REVOLVER RESOURCES

Dianne Copper Mine Recommencement Project

Water Management RFI Response

BNTL01500_0002-REP-001-0

Figure 2.1: Release Dam Contributing Catchment Area

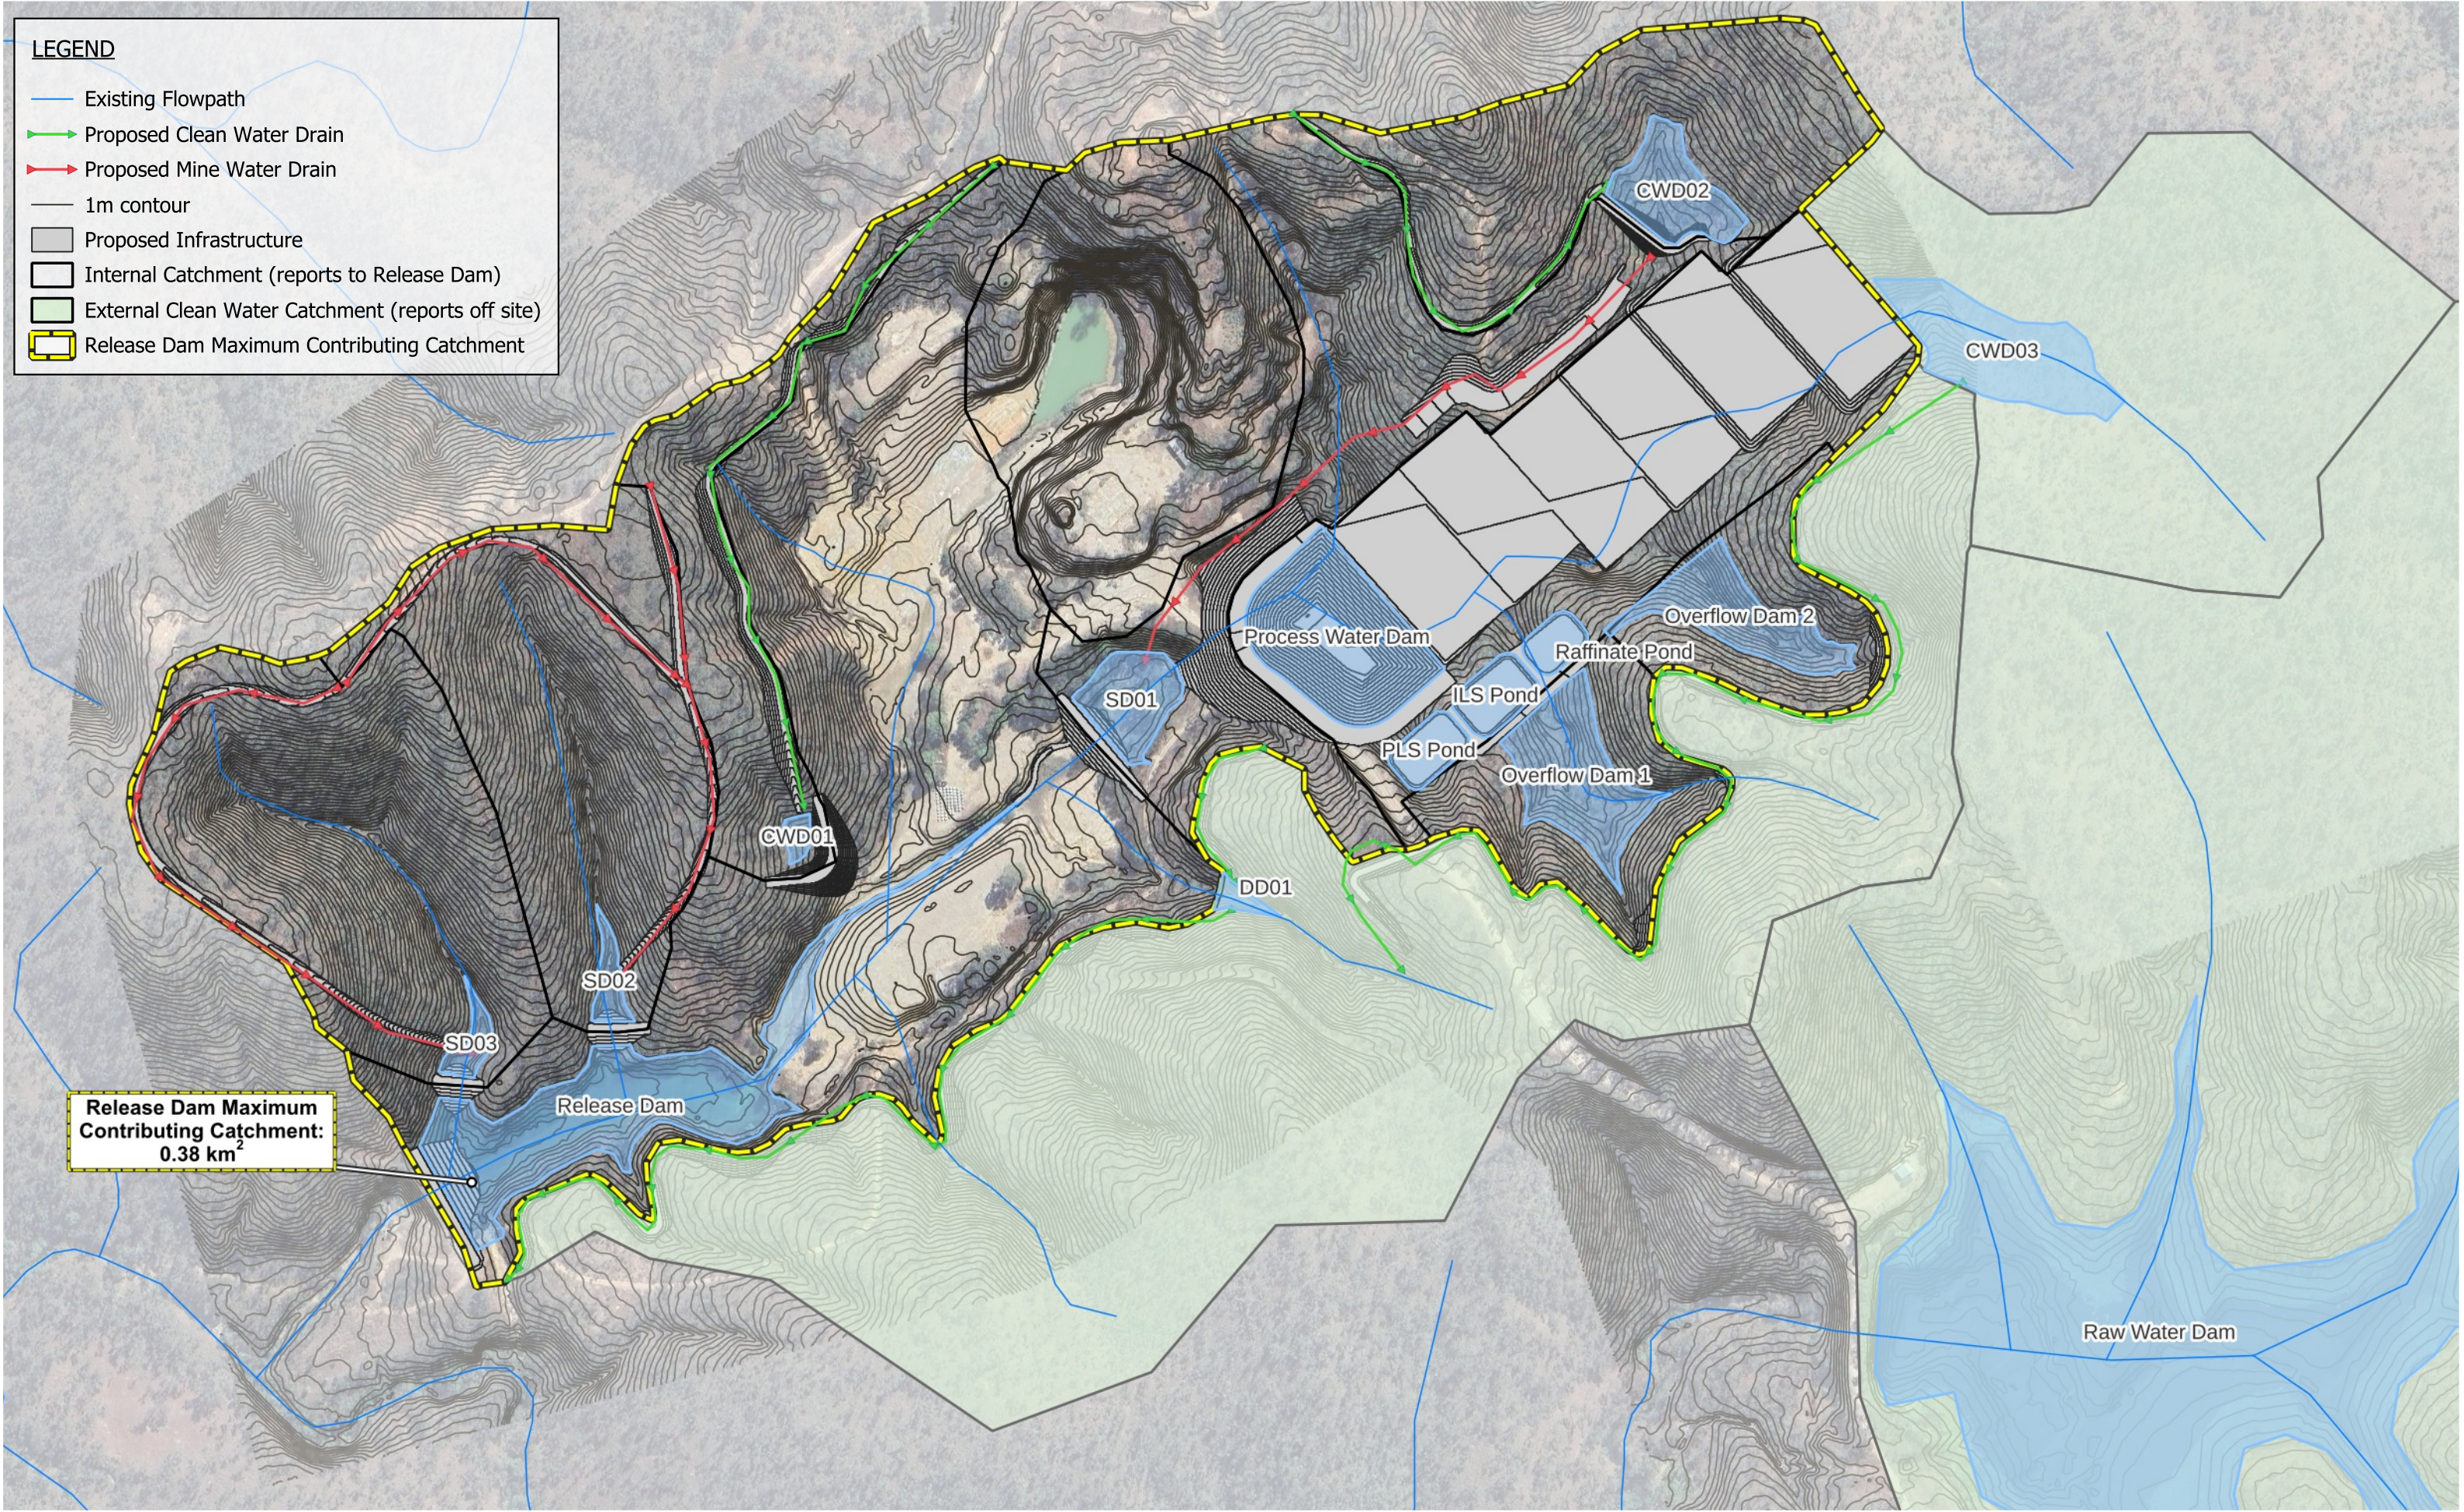
EA11.	Appendix 2 Dianne Copper Mine Water Management Plan	Figure 4.1 in the Water Management Plan shows a catchment boundary line for the contributing catchment upstream of the Settling Dam (to be renamed the Release Dam). However, the area (in km ²) of the catchment area was not provided.	Provide the area (in km ²) for the contributing catchment area upstream of the Settling Dam (to be renamed the Release Dam).	Updated WMP (provided as a separate document) Section 2
		The emphasis in Section 5.3.2.2 is on the annual volumes of water released; not on the potential instantaneous rate of discharge from the Release Dam, which is what determines the required spillway capacity. The total catchment area upstream of the Release Dam would have had to be known, for insertion into the water balance modelling which is discussed in Section 5 of the Water Management Plan.	Provide data on the potential instantaneous rate of discharge from the Release Dam, and how this was calculated to determine the required spillway capacity.	Section 3.3.1

EA11. Provide the area (in km²) for the contributing catchment area upstream of the Settling Dam (to be renamed the Release Dam).

A review of the worst-case contributing catchment area upstream of the Release Dam was undertaken, assuming no pumping or attenuation in upstream storages. The following information, in order of priority, was used to determine the catchment areas:

The individual and overall catchment areas contributing to the worst-case Release Dam catchment are summarised in Table 2.1 and shown on Figure 2.1.

FIGURE 3.4: RELEASE DAM INFLOW AND OUTFLOW RESULT LOCATIONS

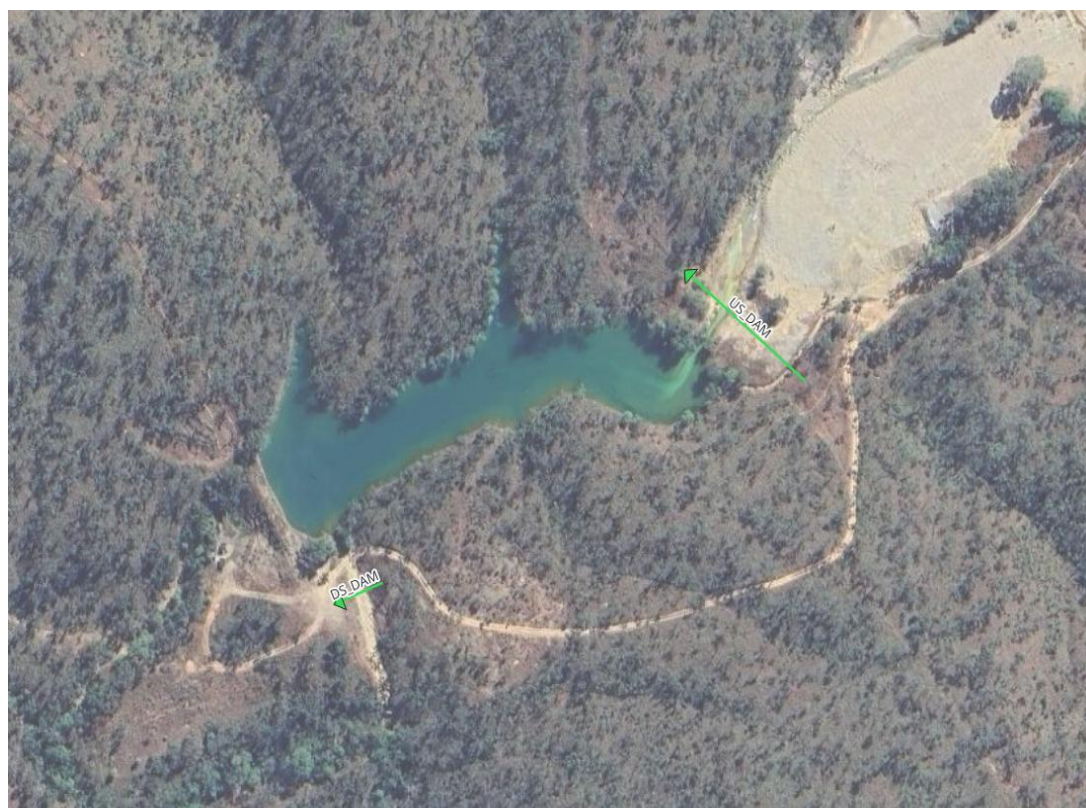
EA11. Provide data on the potential instantaneous rate of discharge from the Release Dam, and how this was calculated to determine the required spillway capacity.

Under a 0.1% AEP, provide estimate of the maximum flood discharge which could occur in the Release Dam, including the instantaneous rate of discharge.

In addition to the 1% AEP, the Proposed Scenario flood model was simulated for the 0.1% AEP to provide an estimate of the maximum flood discharge which could occur in the Release Dam, including the instantaneous rate of discharge.

Peak inflows and outflows for the proposed Release Dam for each event are presented in Table 3.5, for the locations shown on Figure 3.4. Under the 0.1% AEP event up to 720 ML would be discharged from the Release Dam under the maximum contributing catchment scenario (i.e. all storages are full at the start of the event).

FIGURE 3.5 PEAK VELOCITY FOR 1% AEP FLOOD

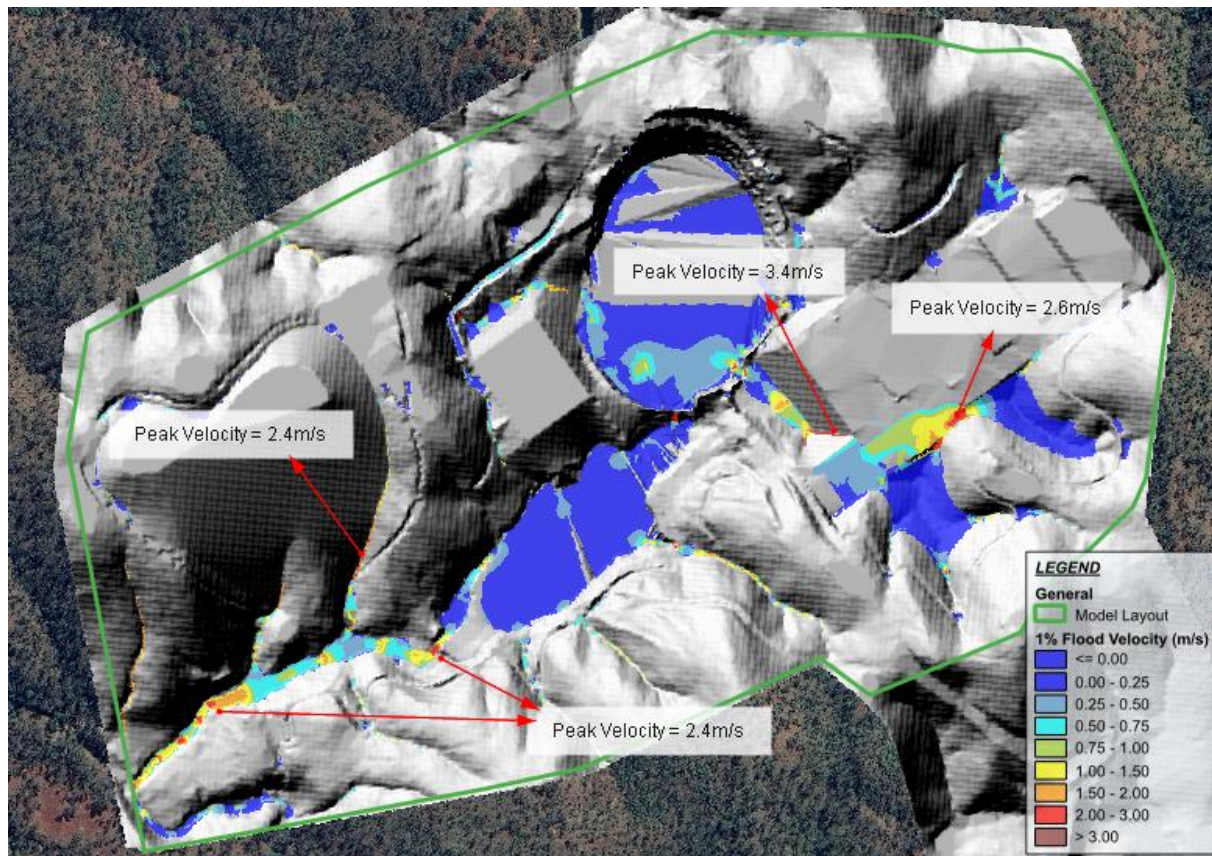
PRCP4. Provide flood depth and velocity for a variety of flood flow events including 0.1% AEP, for the final landform and justify how this will form a stable condition.

Provide information on the future conditions of watercourses, including the geotechnical assessment against flood modelling velocities, the post mining flood model, and justify how this will form a stable condition.

Peak velocity results are presented in Figure 3.5 and Figure 3.6. The highest velocities were observed at the following locations:

- The connecting landform between the Overflow Dams and the capped ILS and Raffinate Pond (2.6m/s-2.8m/s).
- The south-eastern slope within the former Process Water Dam location, which is modified as a drainage line in the final landform, (3.4m/s-4.1m/s).
- Downstream channels in the vicinity of the former Release Dam (2.4m/s – 3.3m/s); and
- The former dirty water drains north of the former Release Dam (2.2m/s - 2.5m/s).

At isolated locations where peak velocities approach 4.0 m/s, a moderate risk of erosion is anticipated. However, given that the majority of the final landform is subject to very low velocities, the overall erosion risk is considered to be low under both the 1% AEP and 0.1% AEP events.
